AGENDA ITEM #14

**GRANTSVILLE CITY
RESOLUTION NO. 2021-30**

To Kristy Clark, Grantsville City Planning and Zoning Administrator
From Shay Stark, Contract City Planner
Date May 7, 2021
CC
Subject Harvest Meadows Subdivision – Preliminary – Planning Commission Memo.

To Kristy Clark, Grantsville City Planning and Zoning Administrator
From Shay Stark, Contract City Planner
Date March 18, 2021 Updated April 12, 2021
CC
Subject Harvest Meadows Subdivision - Preliminary Plan – 1st Review

PRELIMINARY PLAN - HARVEST MEADOW SUBDIVISION

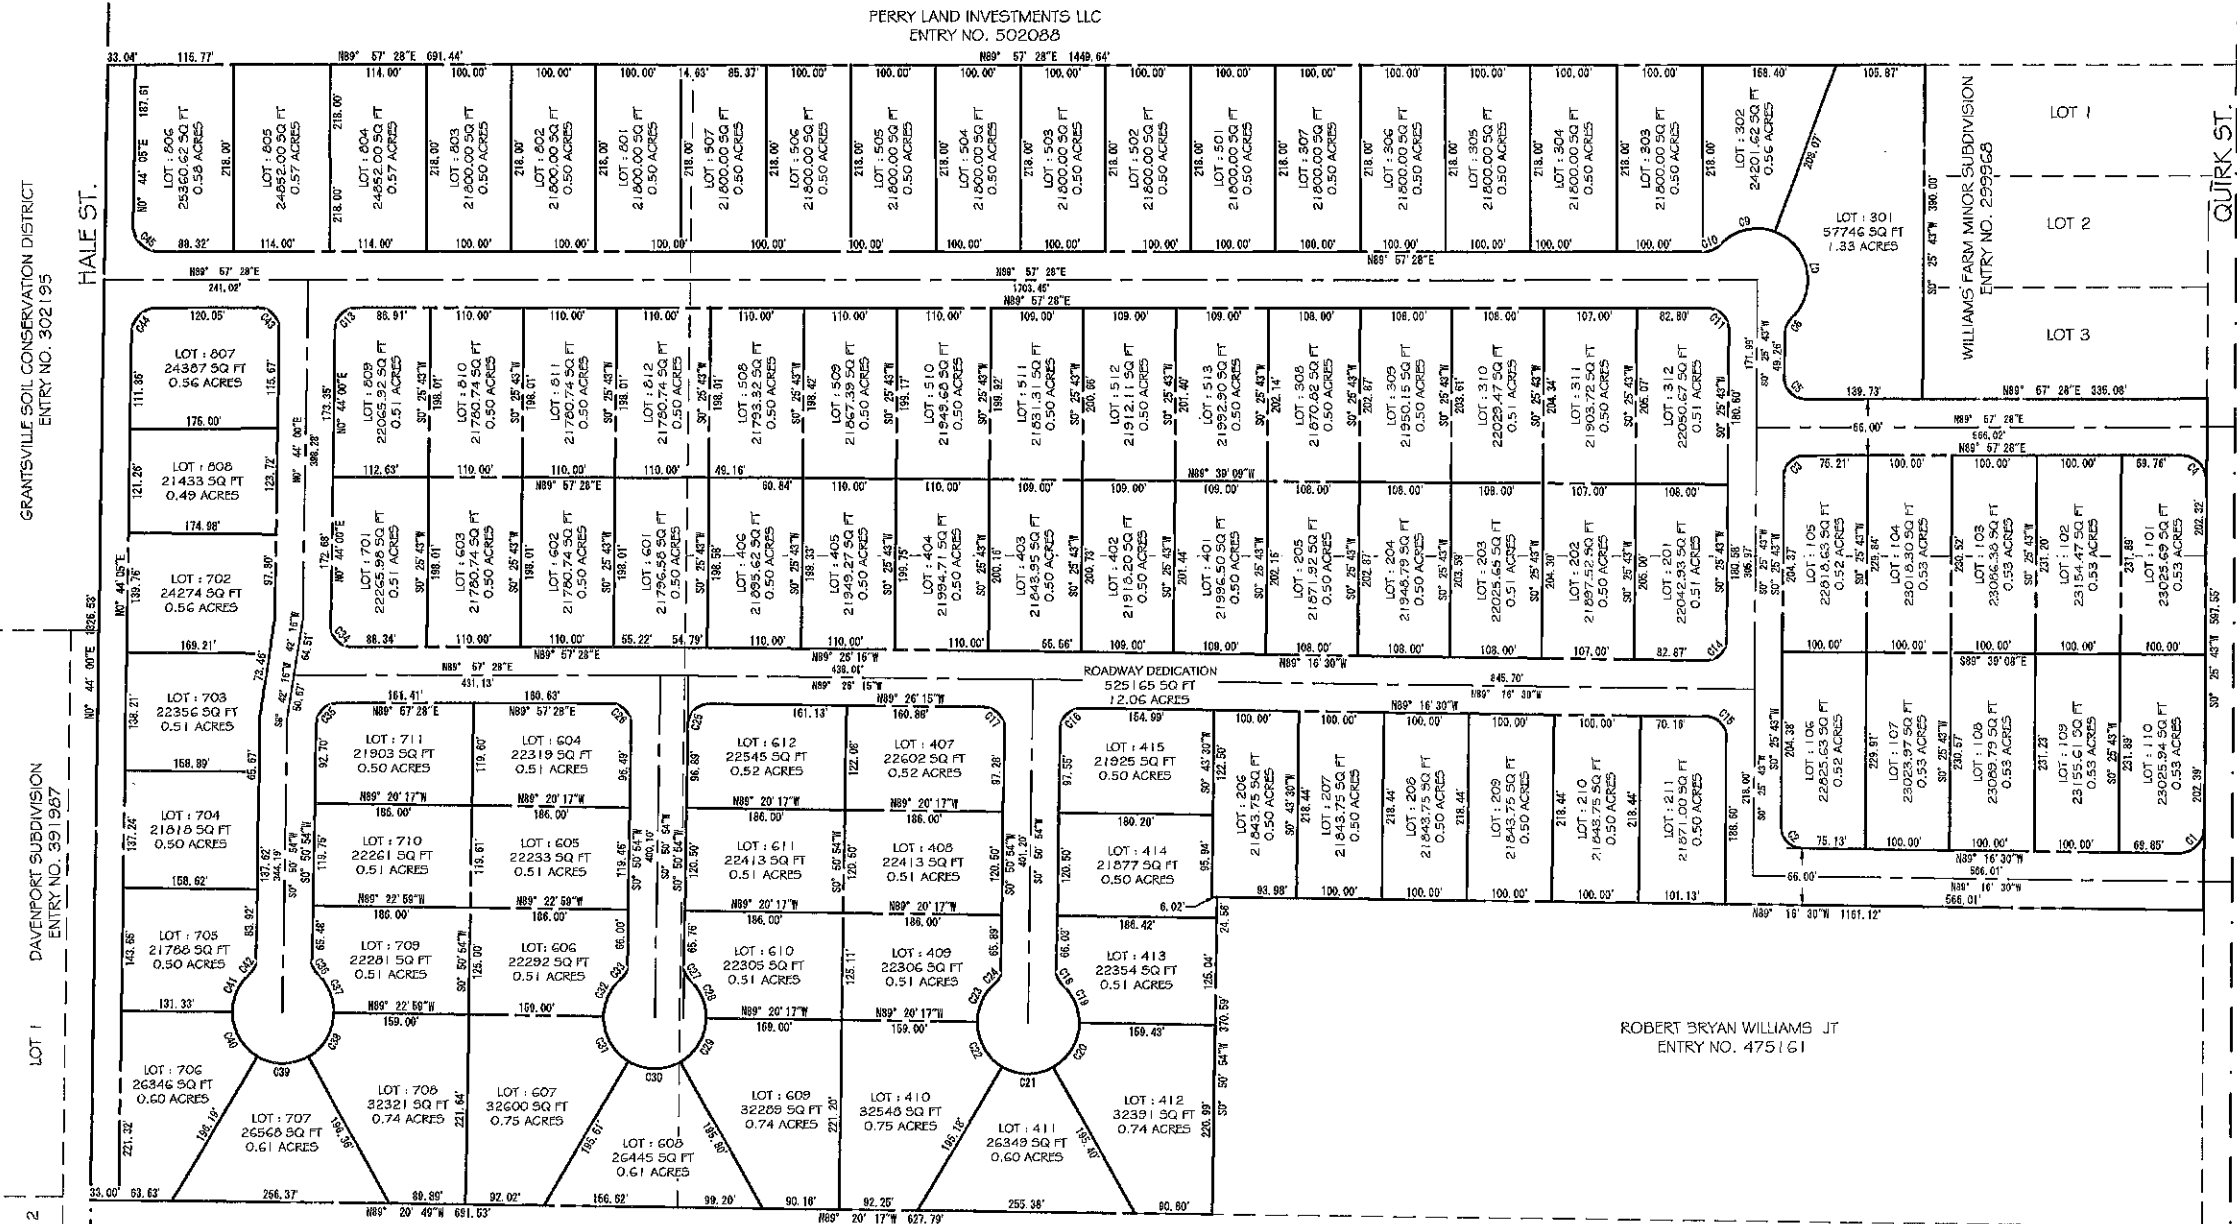
Sheet V-002 – care will need to be taken in locating the utility services to lots 101, 105, 106, 110, 201, 211, 701, 806, and 809 to insure they do not interfere with the placement of the driveway per City code. Building setbacks encroach into/onto the utility easements.

Sheet CP-101 – Is the land for the radii for the corners at the North and South of the frontage dedicated?

Preliminary Plan sheet – Is Quirk Street currently dedicated to minimum street width per the street master plan? No radius is provided at the boundary corners for the street entrances off Quirk. Can the intersections be properly constructed without the radius? Lot 808 does not meet the minimum area. The lot to the North of lot 605 is not numbered and has no area stated. It looks like it will be lot 604 and appears from the dimensions that it will meet the minimum area.
